FILE REF.: CDRC CASE # V/ZA/S 10-5352 Rio Santa Fe Business Park

Peña Blanca Partnership, Applicant, Jim Siebert, Agent, requests a Master Plan Zoning Amendment to an existing Zoning approval, Preliminary and Final Plat and Development Plan approval to create four (4) commercial lots on a 31.44 ± acre parcel for Commercial/Industrial use. The Applicant also requests a variance to allow a Cul-De-Sac (Dead End Road) to exceed 500 feet in length. The property is located at 54 Colony Drive, North West of N.M. 599, North of Paseo De River, within Section 10, Township 16 North, Range 8 East, (Commission District 2).

Reference: Rio Santa Fe Business Park Preliminary/ Final Plat, Final Development Plan, & Master Plan Amendment

To: Jose E. Larrañaga, Commercial Development Case Manager
From: Karen Torres, County Hydrologist 
Re: CDRC Case # MPA/PP/FP/FDP 10-5352 Rio Santa Fe Business Park- Master Plan, Preliminary and Final Plat T16N, R8E, Sec 2, 3 and 10.

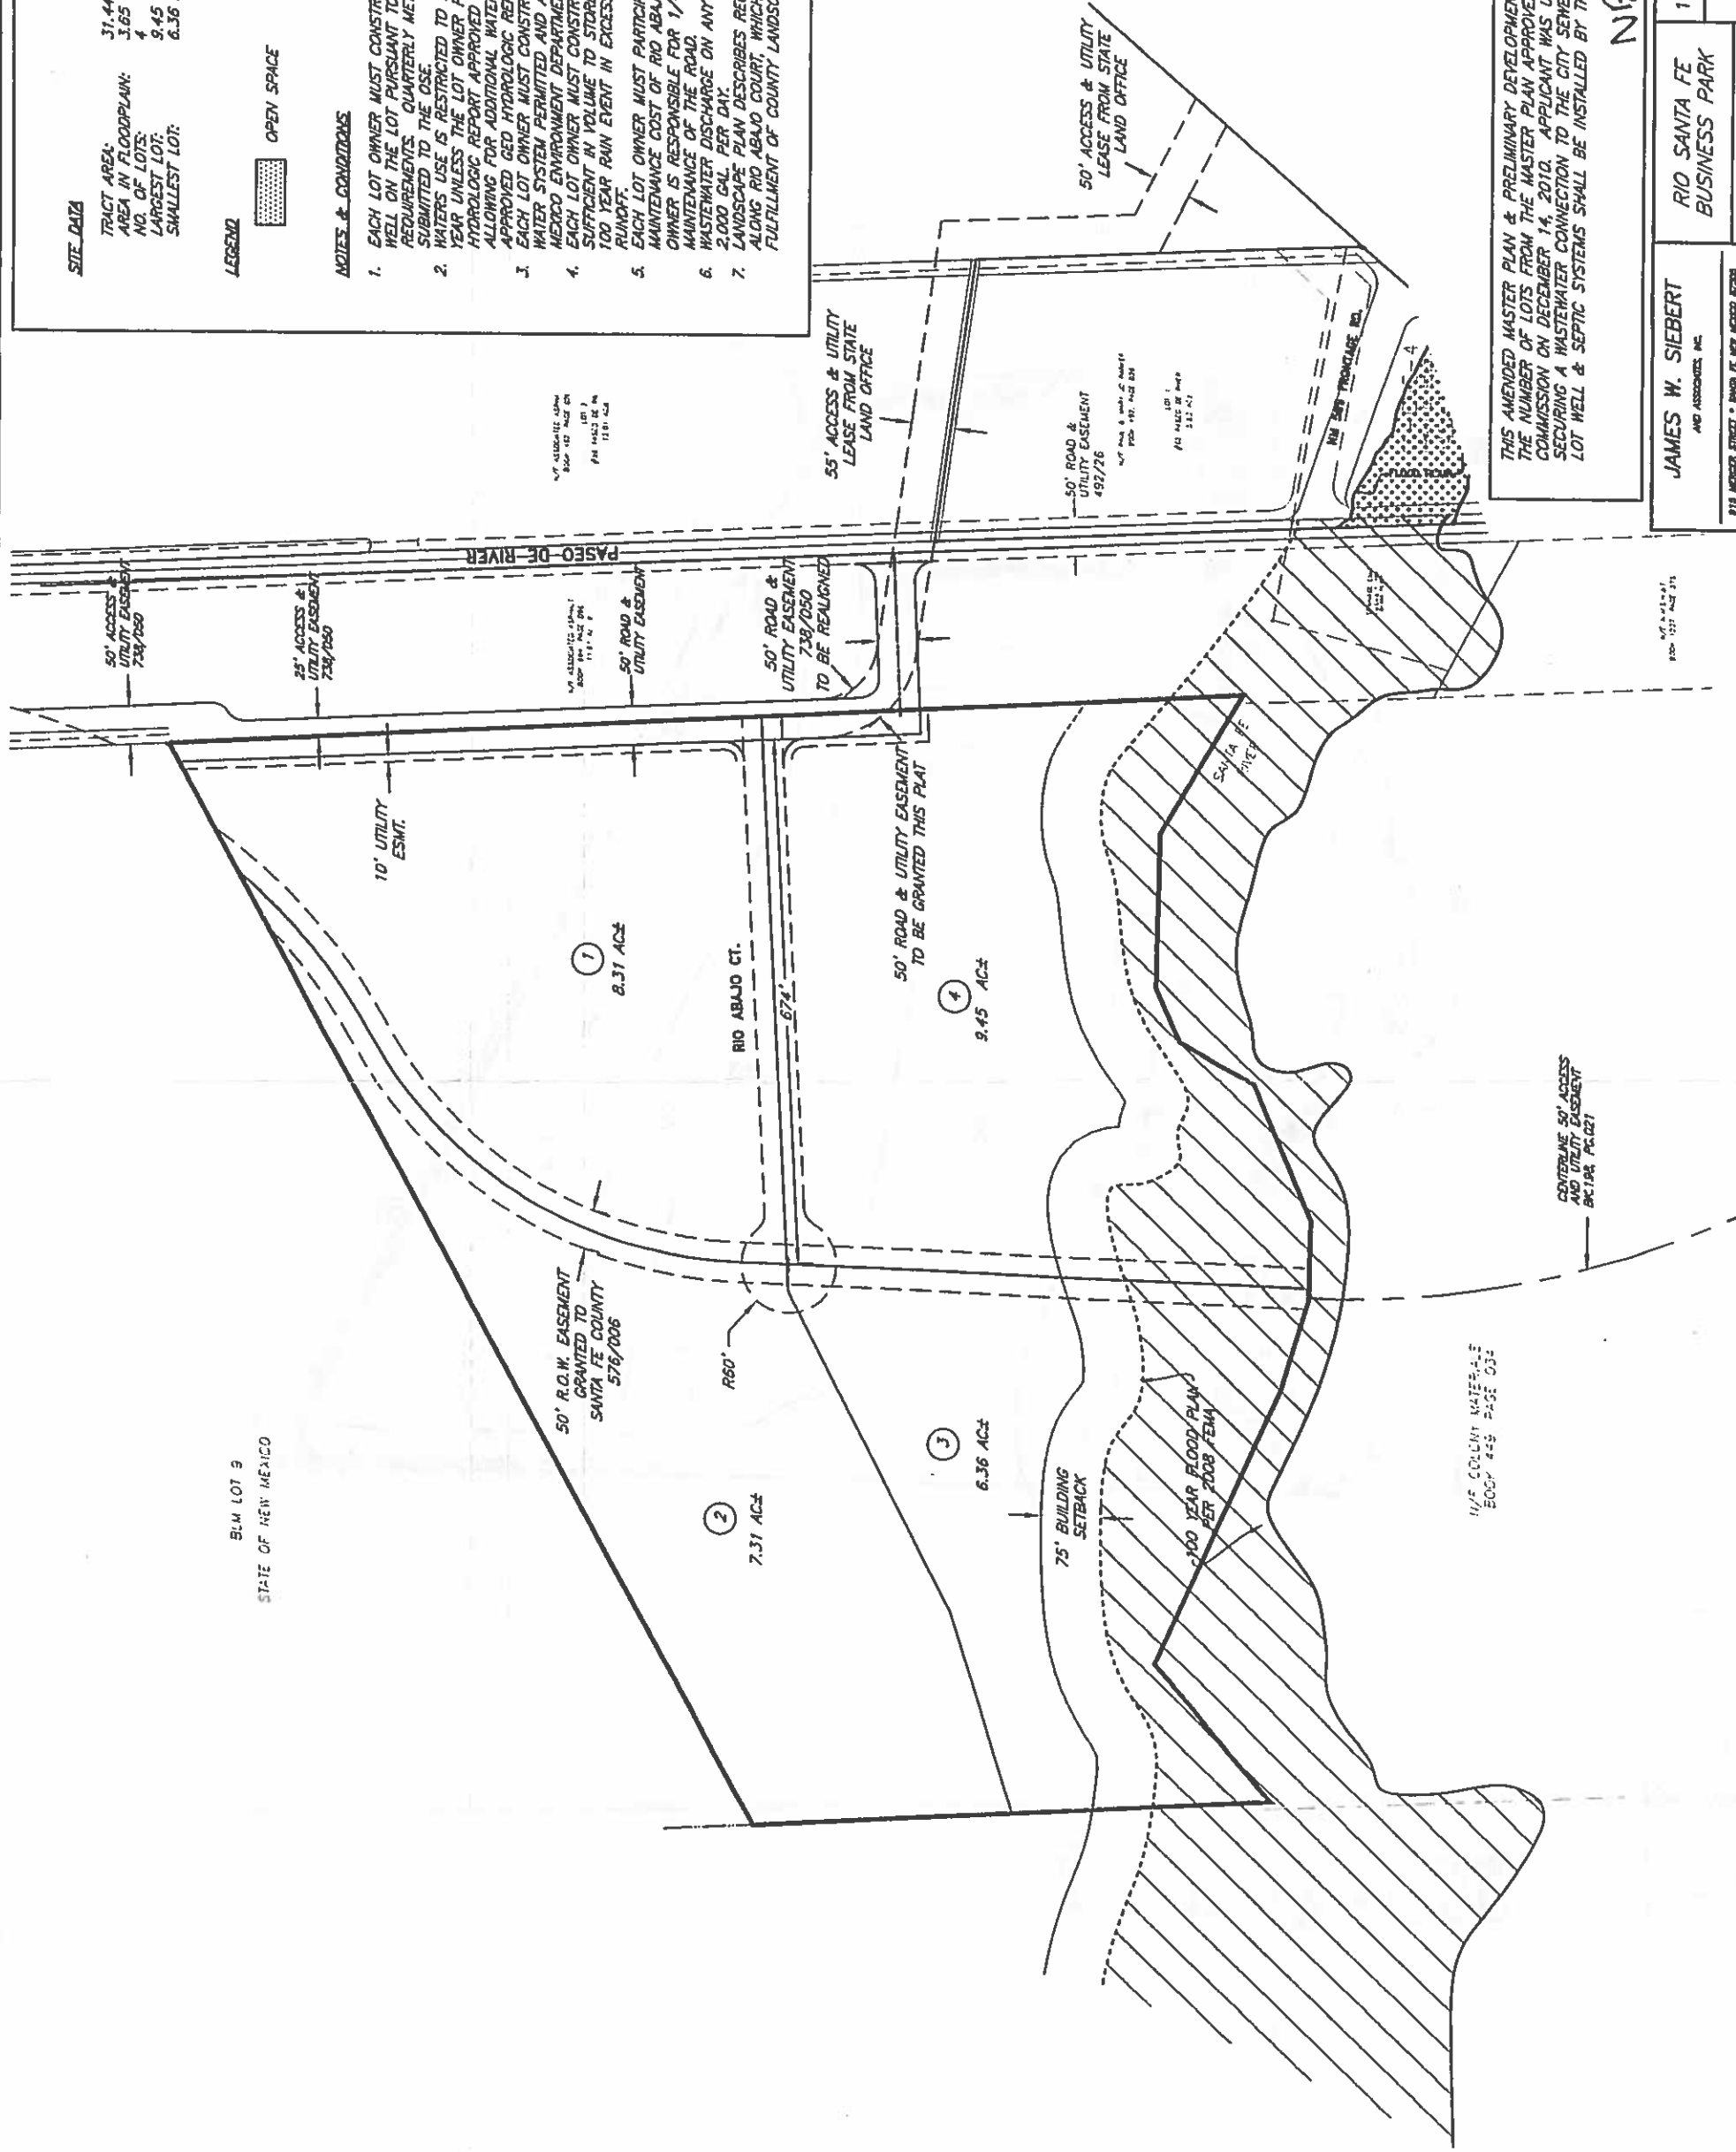
1. Change Item 2 under Notes and Conditions on sheet P-4 to read "Water use is restricted to 0.25 acre-feet per lot per year unless the lot owner prepares a geohydrologic report approved by the County Hydrologist demonstrating water availability as allowed by the code."
2. Include the statement "Submission of a water quality documentation package pursuant to Article VII Section 6.5.1d upon drilling of a well to serve any future development" on the final plat in addition to the disclosure statement.
3. Submission of water restrictive covenants.
